Attachment 1: Figures for Exhibits 1 to 4.
CCNS and EVEMG Comments about draft LANL SWEIS

Figure 1-4.
Schlumberger Permeability Logs for Wells R-28 and R-34

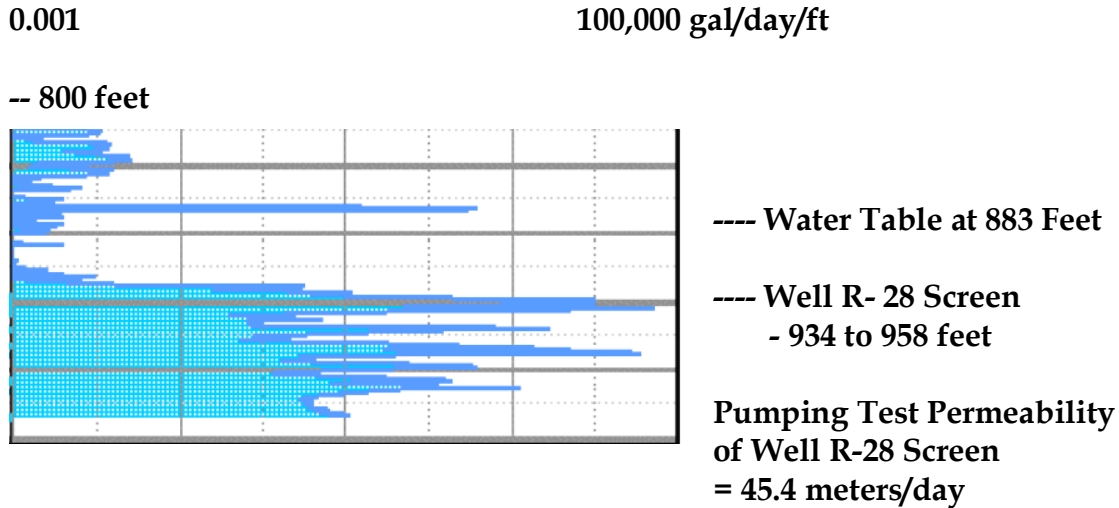
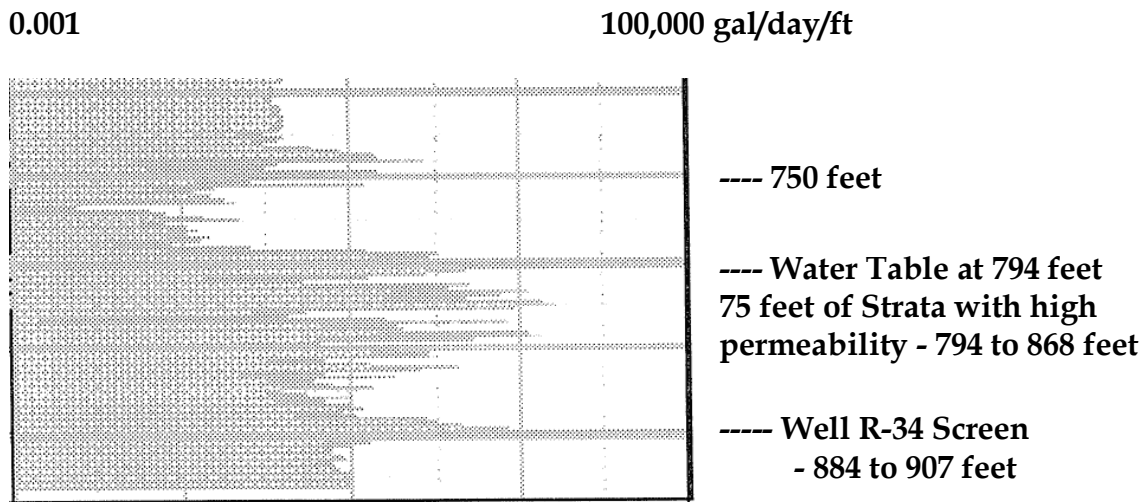
Well R-34 screen installed 90 feet below water table and below 22-ft thick confining bed of clay strata. Strata with high permeability immediately below water table are not monitored.

- Schlumberger Logs show clay strata with very low permeability in depth interval of 868 to 890 feet. The clay strata are across the upper 6 feet of the well screen.
- Because of mistakes, Well R-34 Pumping Test measured a SPURIOUS low permeability of 1.1 meters/day. The regional aquifer at well R-34 may have a permeability greater than 40 meters per day.

Figure 1-5

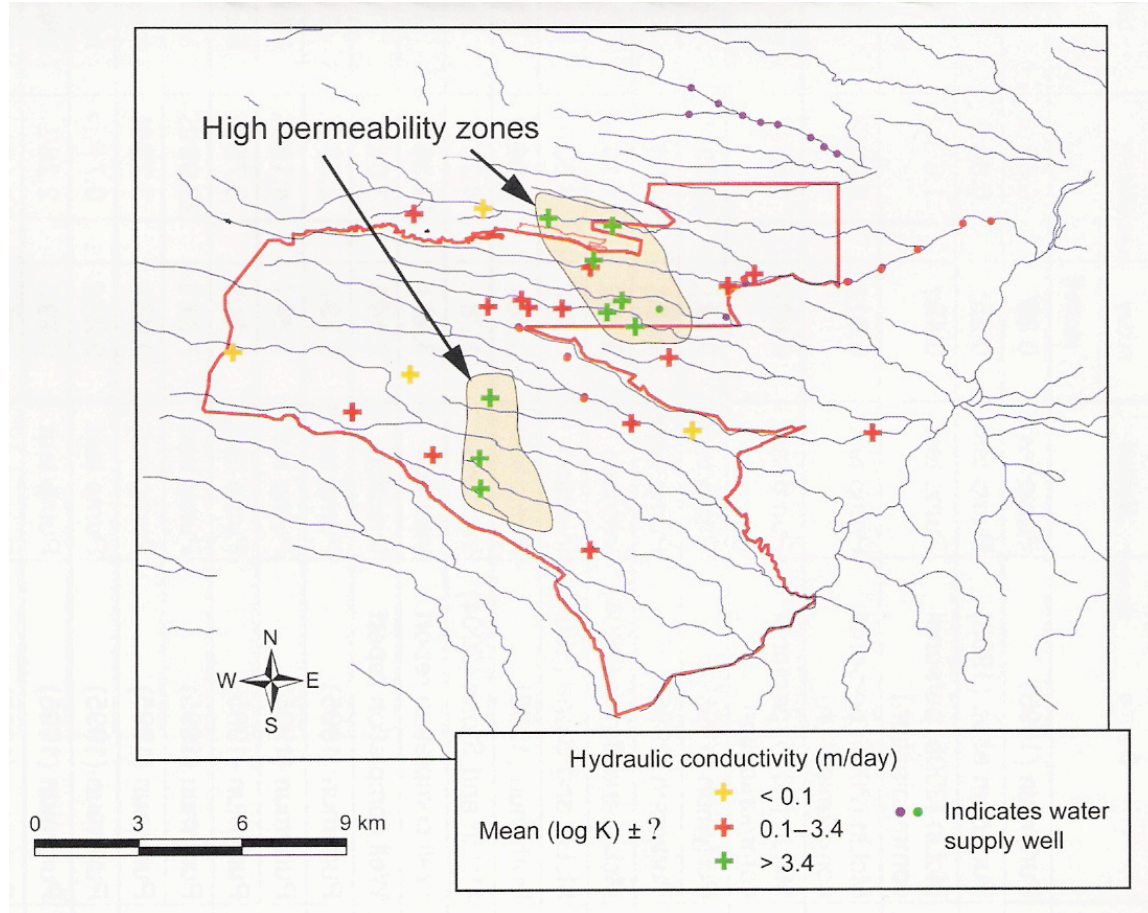
Figure 1-5. The misrepresentation in the LANL *Synthesis Report* that the regional aquifer beneath the San Ildefonso Pueblo does not have high permeability. In fact, the LANL data show that the regional aquifer across the property of the Pueblo has very high permeability – possibly greater than 40 meters per day for much of the Pueblo. The regional aquifer of the San Ildefonso Pueblo is a valuable groundwater resource that must be protected from LANL waste. The high permeability of the regional aquifer increases the danger of widespread contamination of the groundwater of the San Ildefonso Pueblo from LANL waste.

Figure 1-6

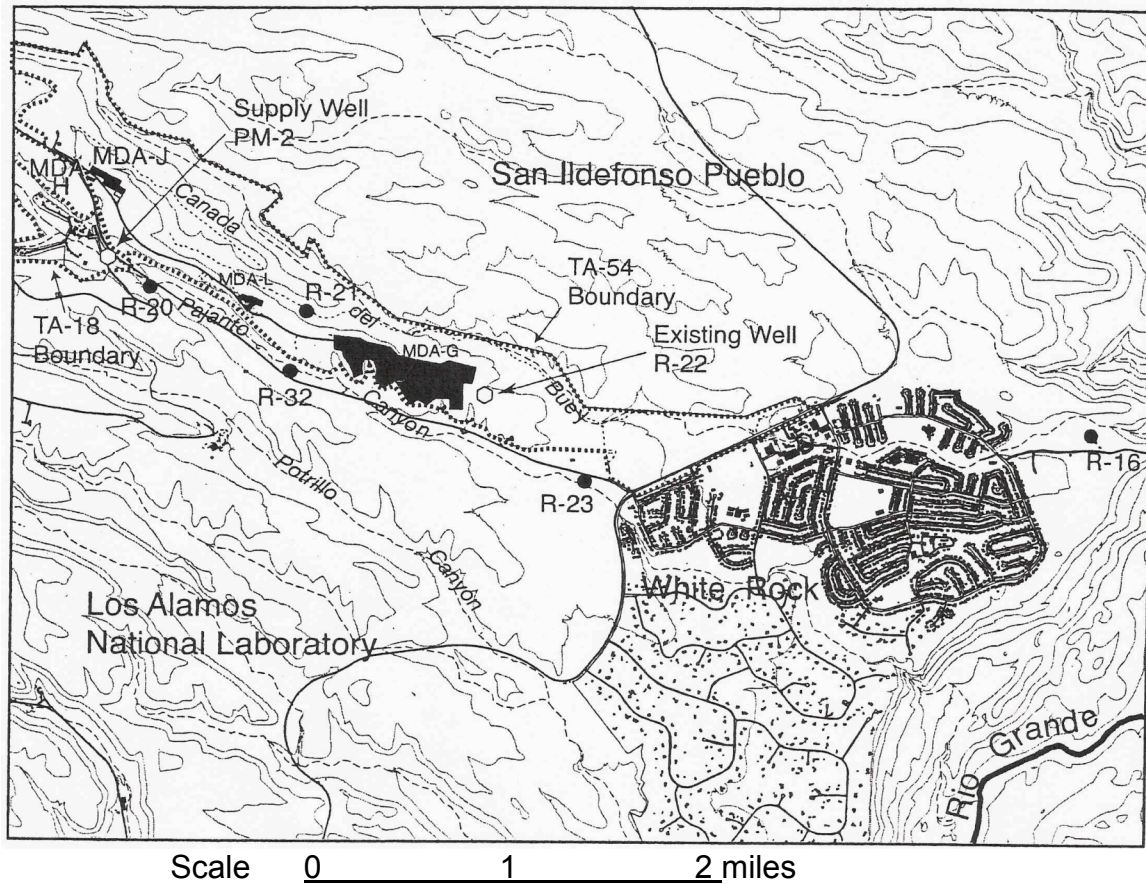
Figure 1-6. The LANL characterization wells R-16, R-20, R-21, R-22, R-23, and R-32 that surround the three RCRA regulated units MDA G (Area G), MDA L, and MDA H. None of the six wells meet the requirements of RCRA for monitoring groundwater contamination.

Figure 1-7.

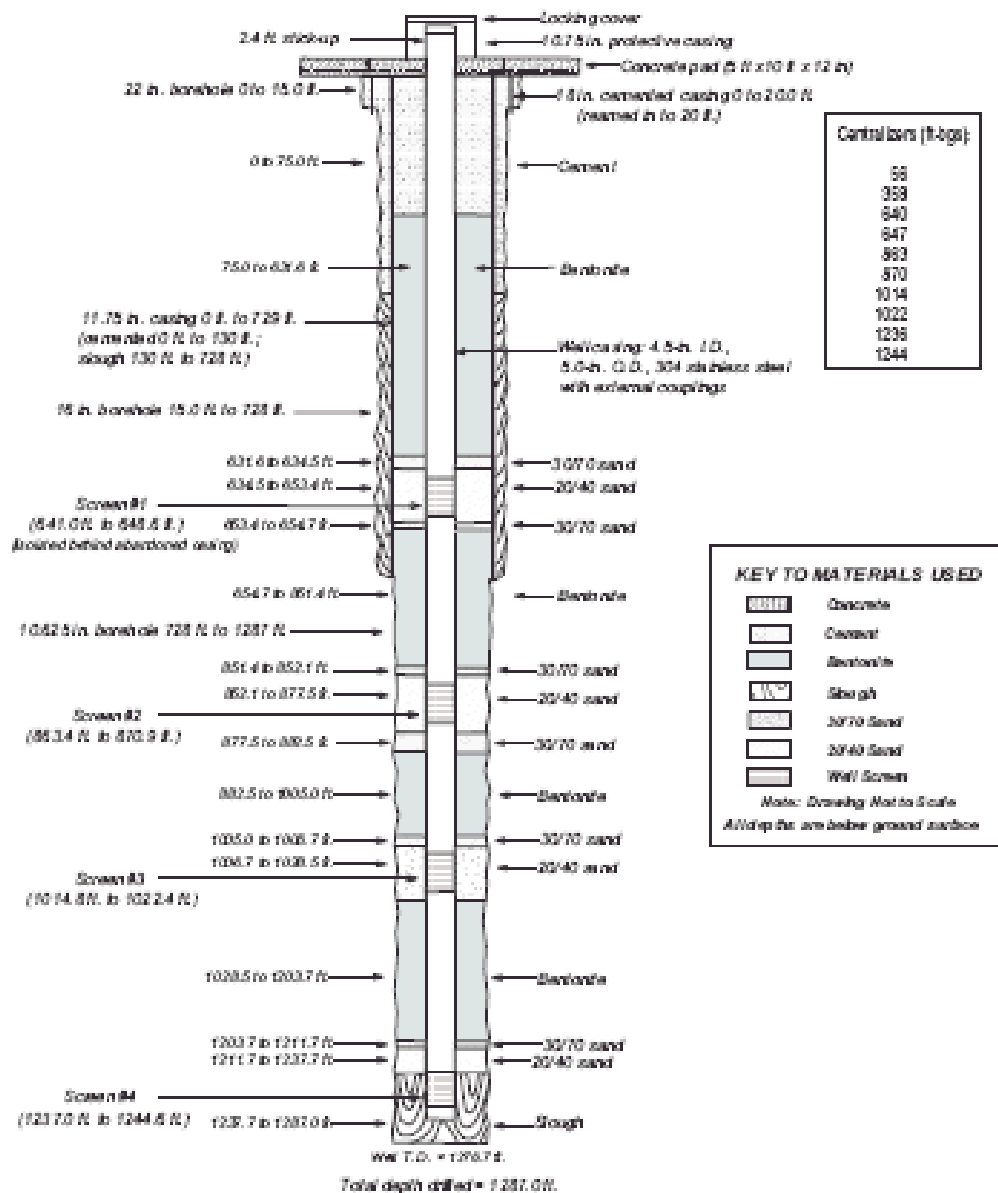
As-built construction of LANL characterization well R-16, a sentry well for LANL contaminants traveling to the Rio Grande and to the Buckman well field. Screen #1 is blocked off by retractable drill casing that was abandoned in the borehole. Screen #4 does not produce representative groundwater samples because the screen is surrounded by bentonite clay slough sediments that were not cleaned from the borehole

Figure 1-8.

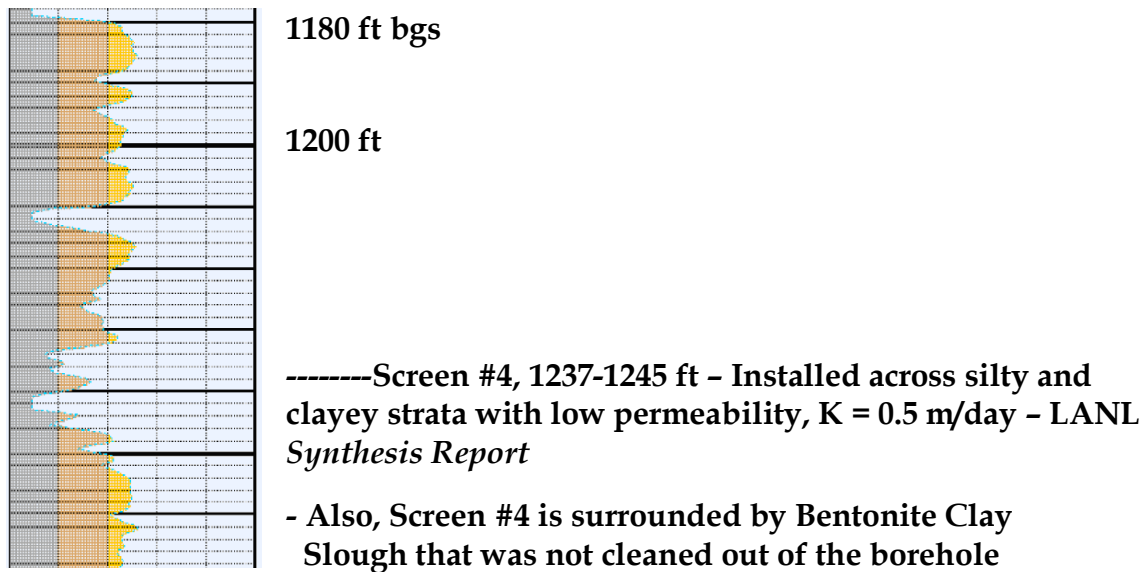
Strata with markedly higher permeability are at a depth of 1180 to 1188 feet and at a depth of 1252 to 1262 feet below ground surface (bgs).

- Well R-16 was drilled with the Conventional Mud Rotary Method.
- All of the screened intervals are invaded with large quantities of Bentonite Clay Drilling Mud and Organic Additives. None of the Screened Intervals in LANL Well R-16 meet the requirements of RCRA Subpart F.

- The contaminated and mixed drill cuttings are not useful for identifying the strata with highest permeability that are appropriate for monitoring
- The borehole geophysics were the best information for locating the well screens in well R-16 but the Schlumberger report shows that the well screens are not installed in the aquifer strata that are important for long-term monitoring.

- There is a need to install a new monitoring well near the location of well R-16 to monitor the aquifer strata that may form a pathway for contamination from LANL to travel beneath the Rio Grande to the Buckman Well Field, and important water supply for Santa Fe.
